Engineering Change Order – Class I

The CMS ZDC

Brief description of the proposed change(s) :

Fig. 1 Side View of the CMS ZDC

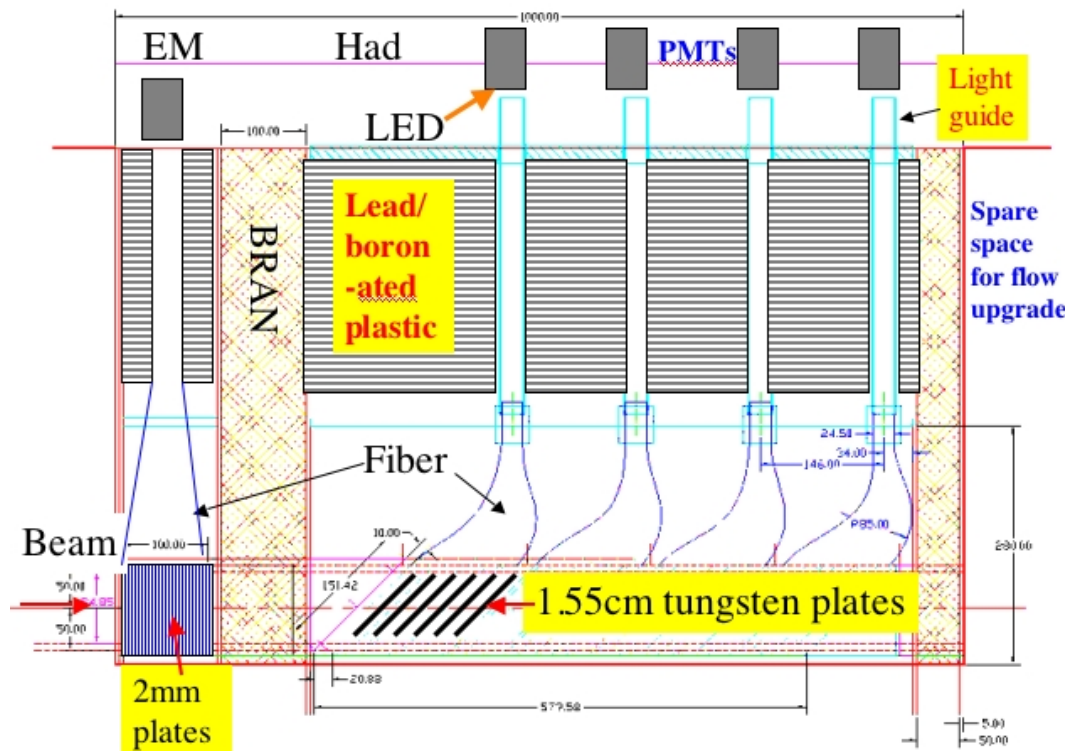
The EM section is made of 33 layers of 2 mm thick tungsten plates and 33 layers of 0.7 mm diameter quartz fibers. The HAD section consists of 24 layers of 15.5 mm thick tungsten plates and 24 layers of 0.7 mm diameter quartz fibers. The fibers are grouped together to form readout bundles and are coupled to photomultiplier tubes (PMT).
